FORD 4R100 "UPDATE HANDBOOK"

FORD 4R100 "UPDATE HANDBOOK"

Since the introduction of the 4R100 transmission in model year 1998, there have been many engineering changes to improve Pleaseability, Reliability and Durability concerns. These changes have affected most every part used in this transmission. This "Update Handbook" will explain each change, the reason for the change, and any parts interchangeability concerns created by the change, along with any part numbers needed to update your transmission.

Figure 38

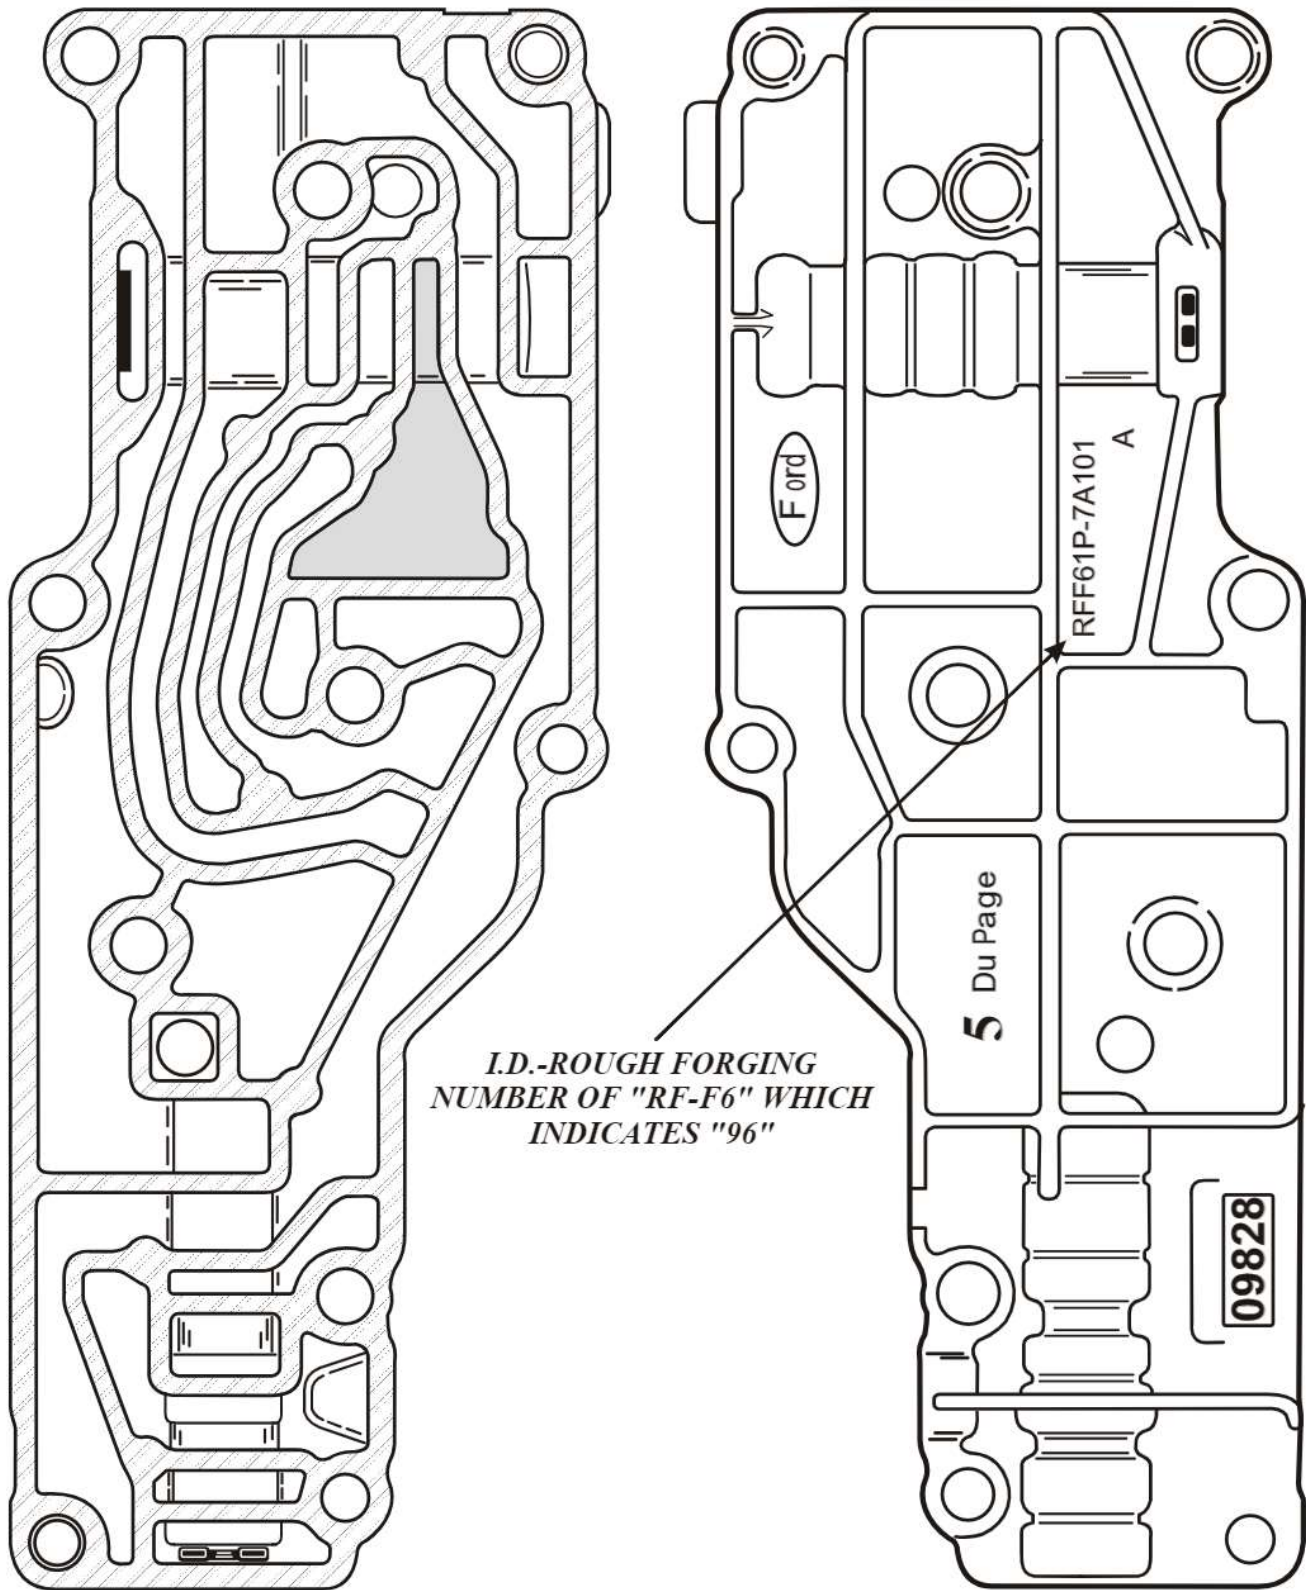
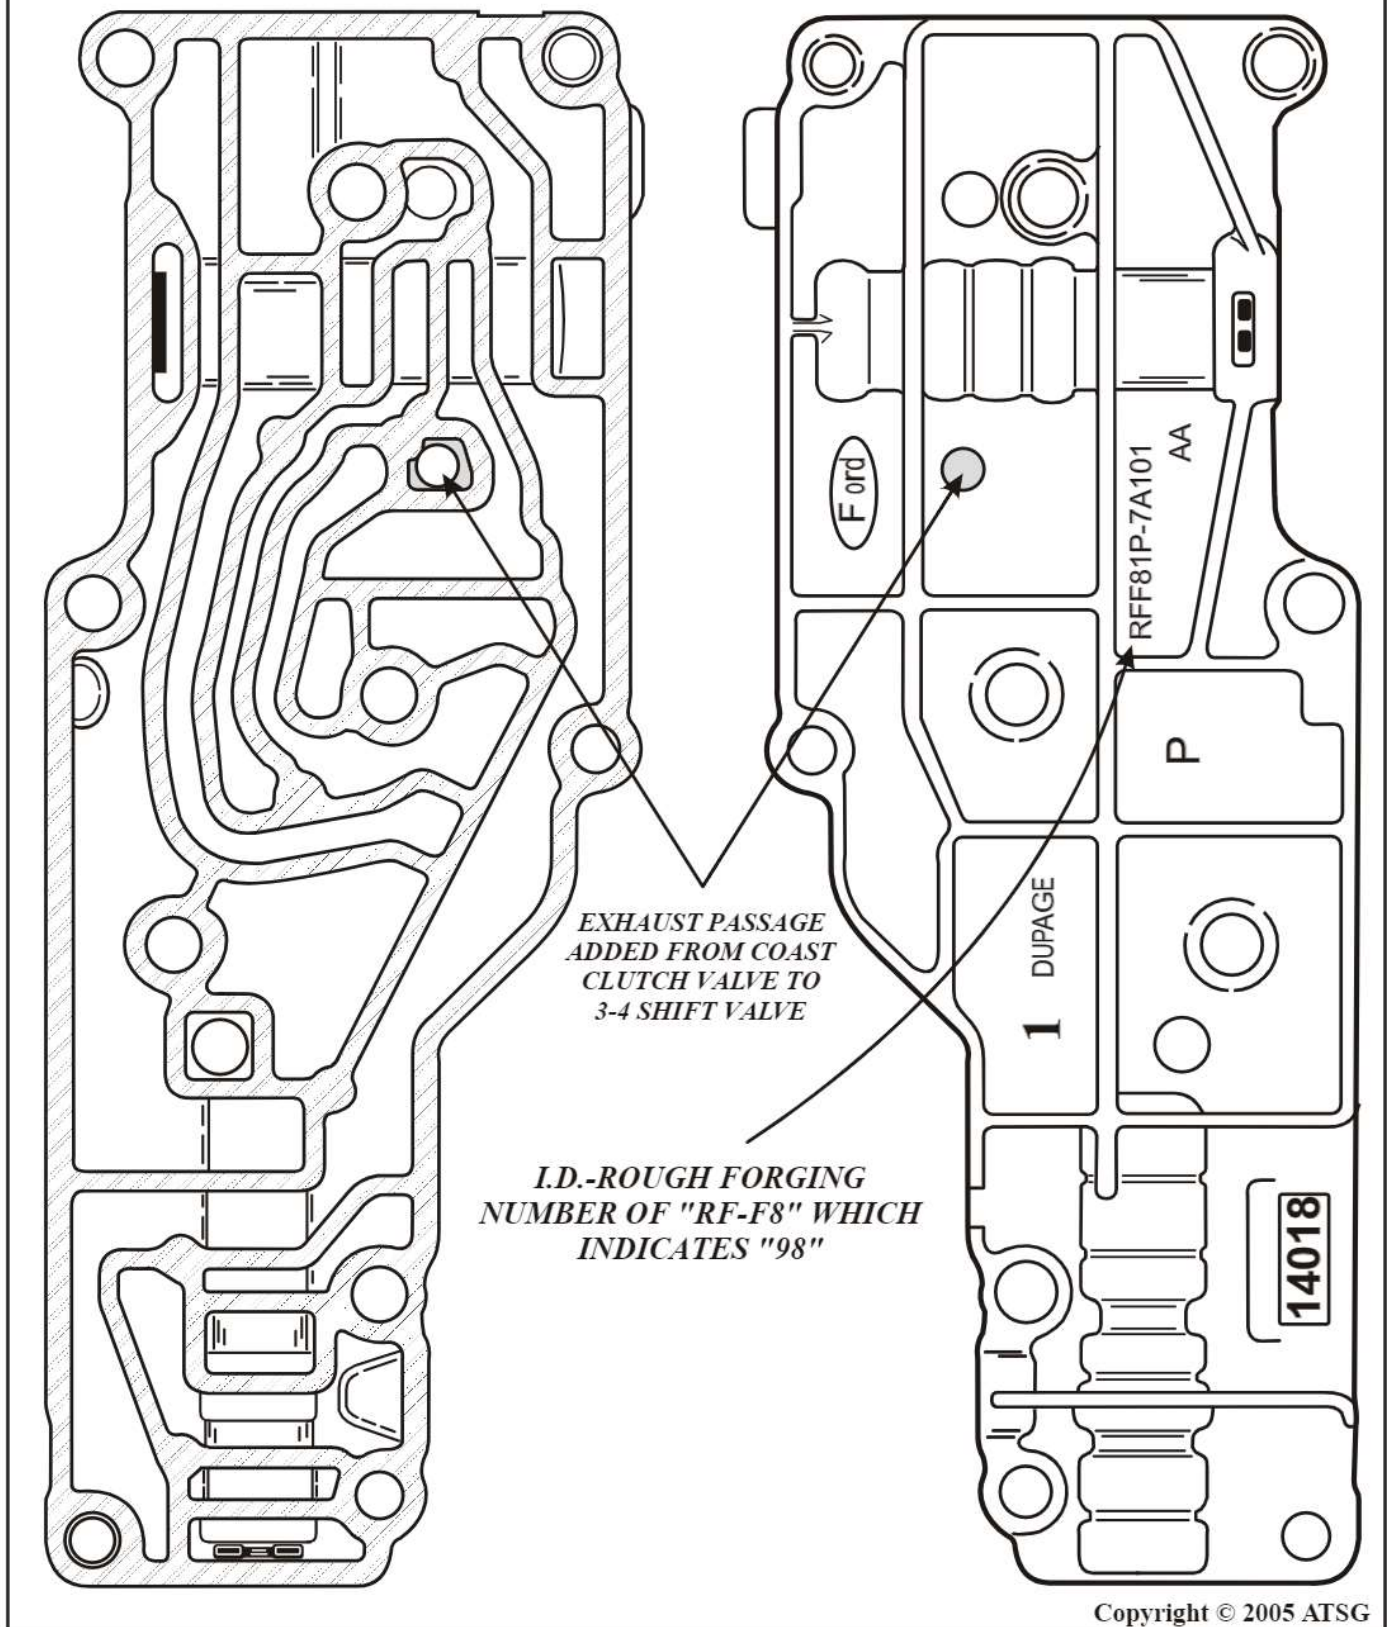
- (4) **LOWER VALVE BODY:** The Lower Valve Body had a passage added, as shown in Figure 38, to connect to the "new" exhaust passage in the Main Valve Body. Refer to Figures 37 and 38 for identification of "NON-PTO" and "PTO" Lower Valvebody's.

Figure 40

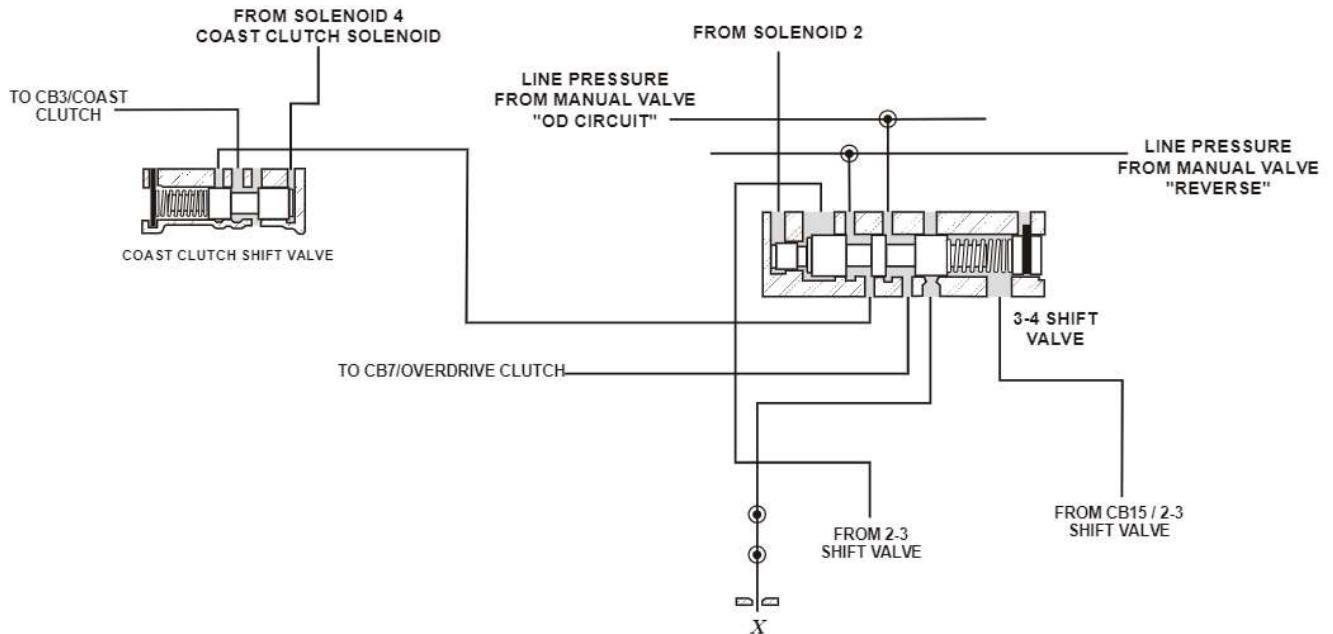
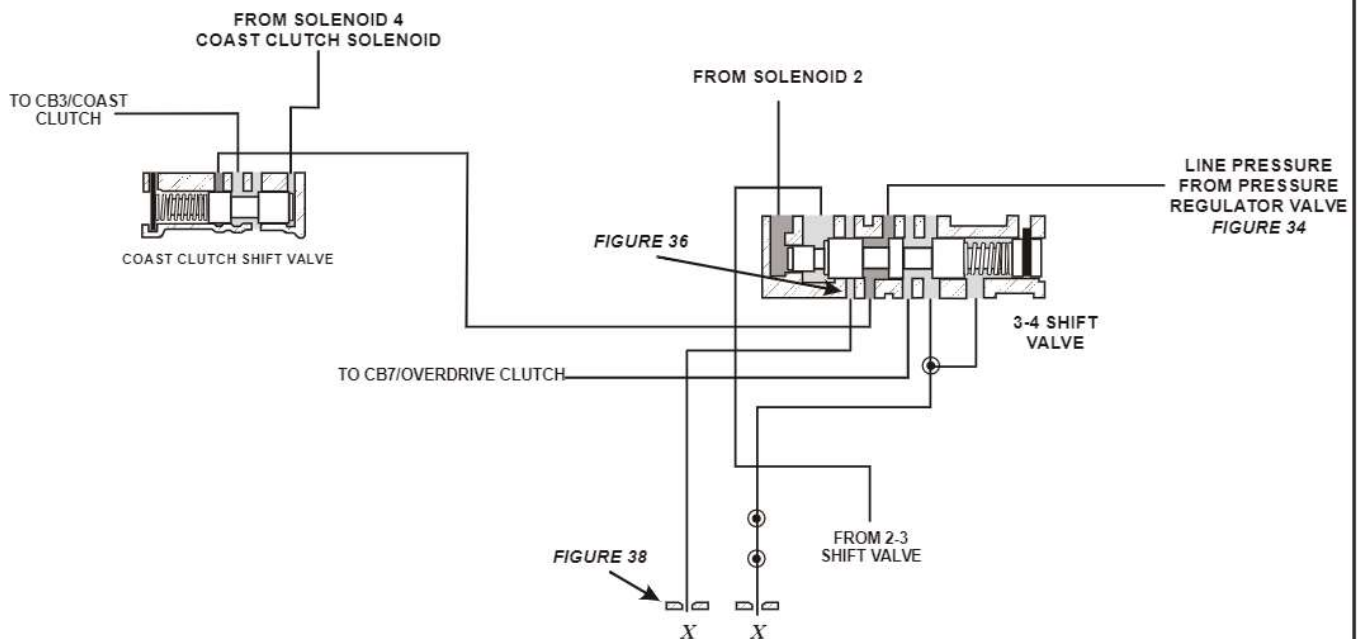
Partial Hydraulic Schematic is provided for you in Figure 40 on Page 49.

Figure 41

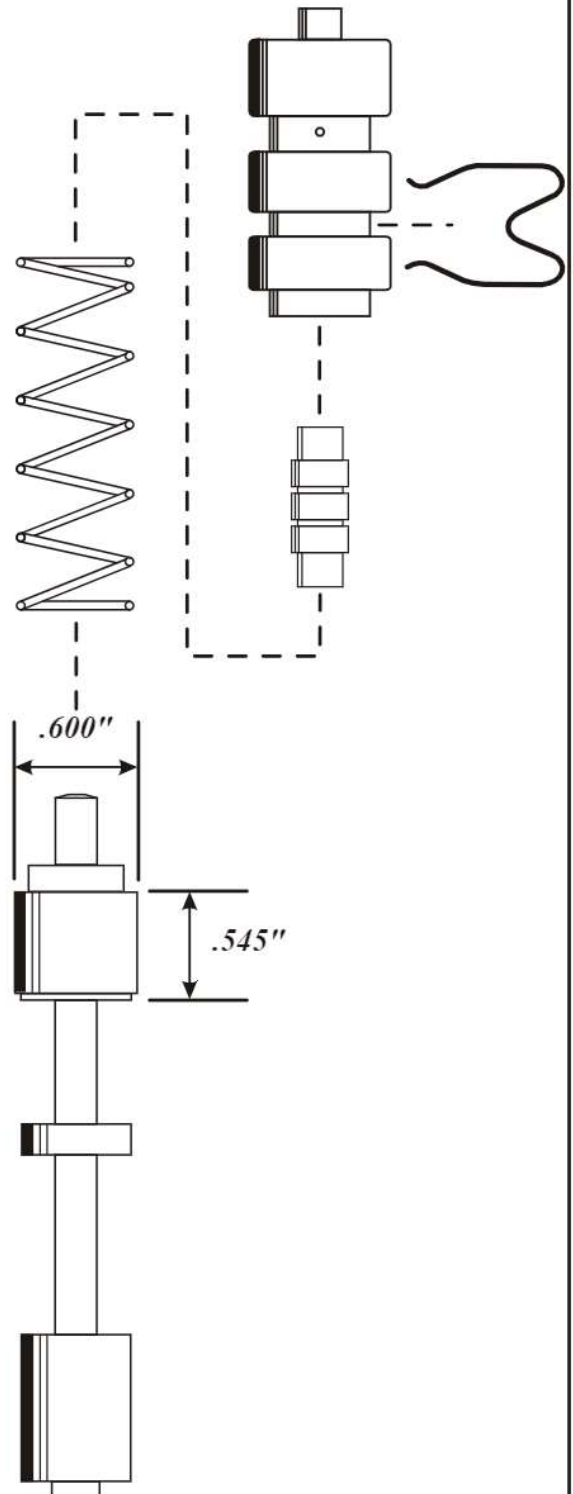
- The pump cover assembly had the rear of the Converter Clutch Valve bore enlarged approximately .070" to accommodate the enlarged land of the Converter Clutch Valve, as shown in Figure 41.
A .036" orifice and an air bleed were added to the TCC Solenoid signal passage, as shown in Figure 43.

- The Converter Clutch Control Valve's rear spool was enlarged approximately .070". There was also a bushing and valve added to the end of the valve train, as shown in Figure 41.
A hole was added to the pump cover to connect the Converter Clutch Control Valve Bushing to Converter Regulator Valve oil, as shown in Figure 43.

THE DIAMETER AND THE LENGTH OF THE SPOOL ON THE VALVE LAND SHOWN ABOVE, WERE INCREASED ON PWM VERSIONS. THE BORE IN THE PUMP WAS ALSO ENLARGED APPROXIMATELY .070" TO ACCOMMODATE THE CHANGES IN THE DIAMETER OF THE VALVE
